# SERVICE BULLETIN

No. 759

Subject: Exhaust muffler inspection and modification,  
Piper Part Number 12433-00, 12433-14,  
12232-00.

Models Affected: PA-18 Series Super Cub

VIEW A-A

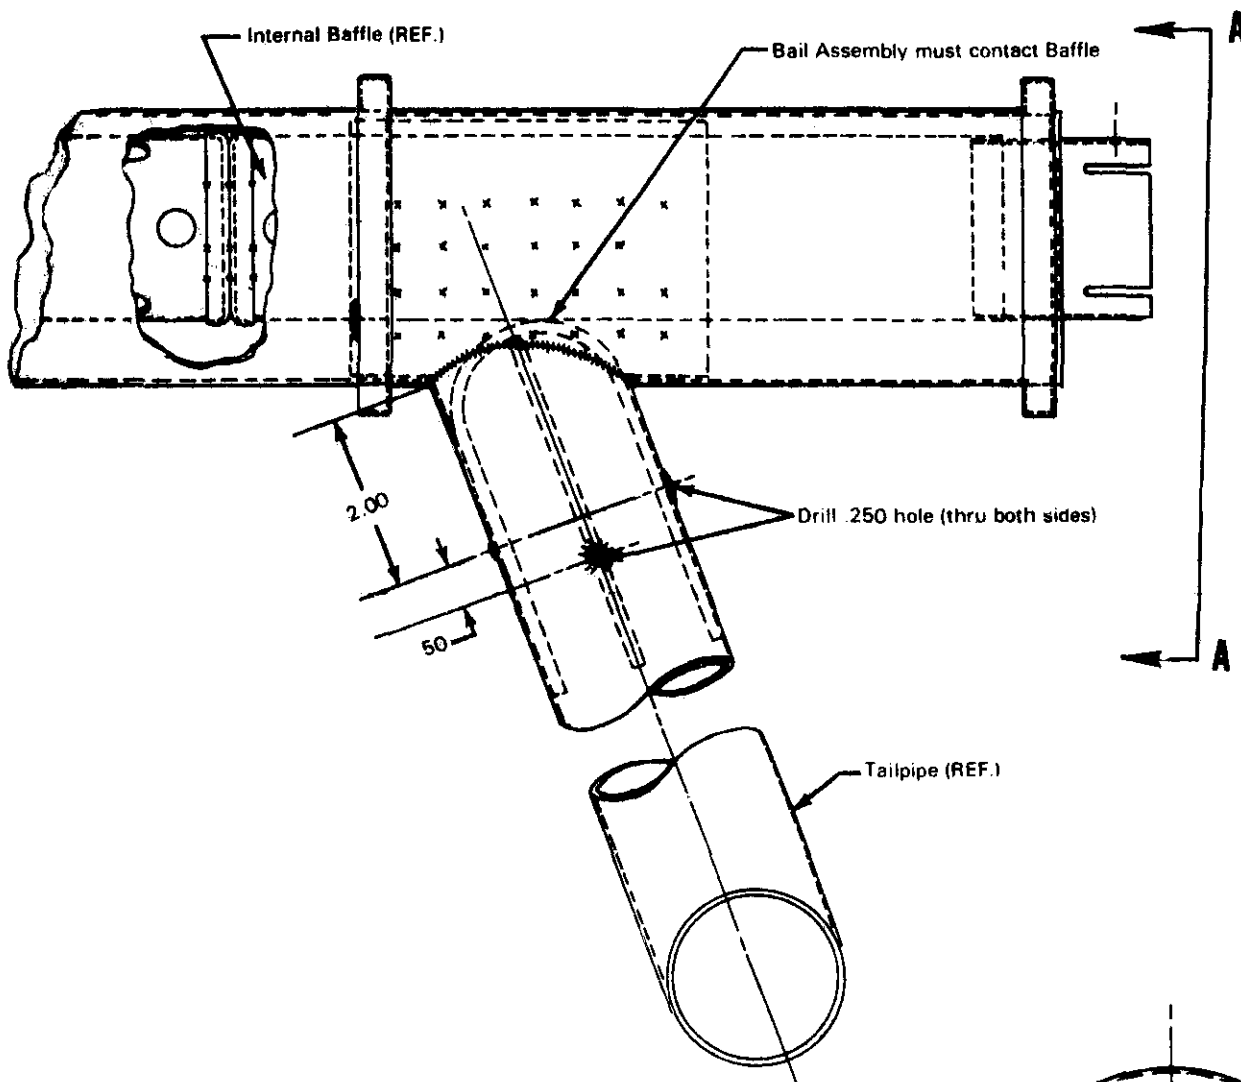
7. Remove shroud from muffler assembly and comply with AD 68-05-01.
8. Drill two 1/4 inch (.250) holes through the tailpipe as shown in the following sketch.
9. Install bale assembly, Piper Part Number 452 093 into tailpipe, curved end toward the muffler until contact is made with the internal baffle. The deflector must be installed so that the opposing legs cover the four holes that have been previously drilled.

10. Rosette weld by suitable method the bale through the four 1/4 inch holes in tailpipe.
11. Reassemble muffler assembly and reinstall on aircraft. Install exhaust system components and reconnect any lines, wire, and hoses that were removed. Attach engine properly and reinstall engine cowling that was removed.
12. Make appropriate log book entry stating compliance of this Service Release.

Rosette Weld (4 Required)

Bail Assembly (P/N 452 093)  
(Should Be A Light Press Fit With  
The Four Rods Making Contact  
With Inside Wall Of Tailpipe,  
Slight Reshaping May Be Required)

#### SPECIAL TOOLS FABRICATION DETAIL

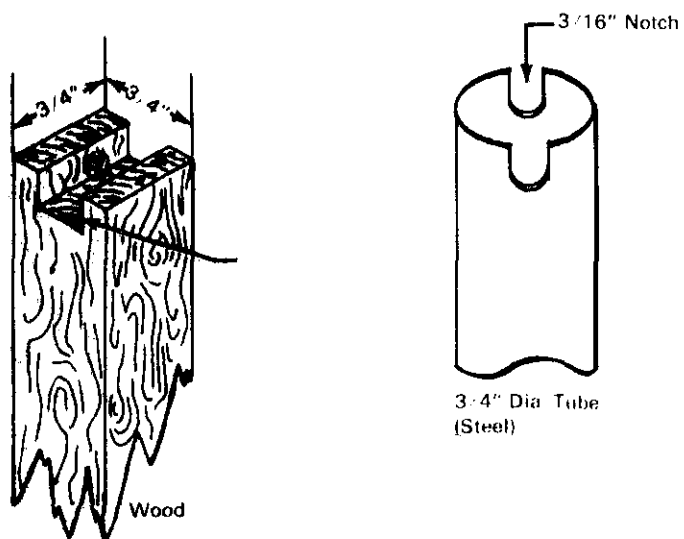
Note: A 3/4 inch square x 18 inch long stick of wood or 3/4 inch diameter x 18 inch long metal tube may be fabricated into a special tool to twist the deflector if necessary after installation to locate two of the legs directly inside the 1/8 inch holes in the tailpipe. (See sketch).
